# Economic and Social Council

### World Forum for Harmonization of Vehicle Regulations

## **Proposal for Supplement 19 to the original series of amendments to UN Regulation No. 75 (Tyres for L-category vehicles)**

### **Submitted by the Working Party on Noise and Tyres\***

*Annex 2*, amend to read:

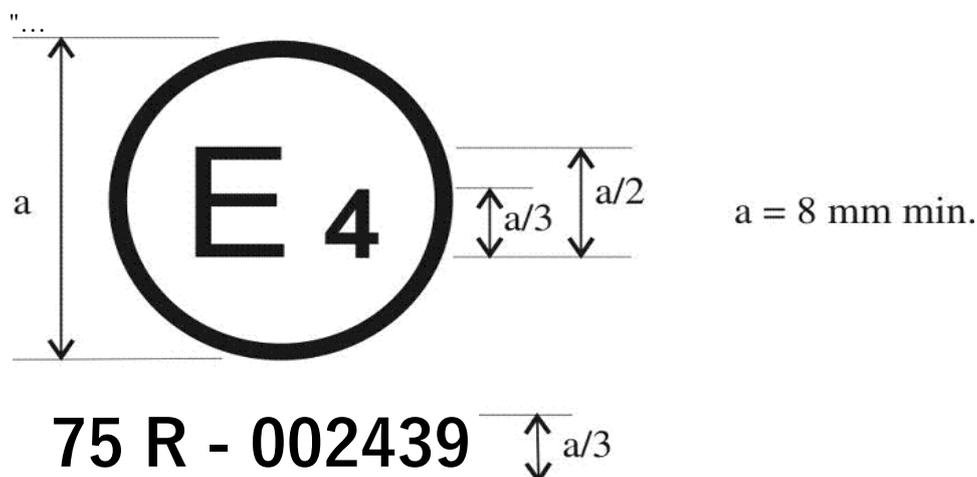
The above approval mark affixed to a tyre shows that the type of tyre concerned has been approved in the Netherlands (E 4) pursuant to UN Regulation No. 75 under approval number 002439. The first two digits of the approval number indicate that the approval was granted in accordance with the requirements of UN Regulation No. 75 in its original form.
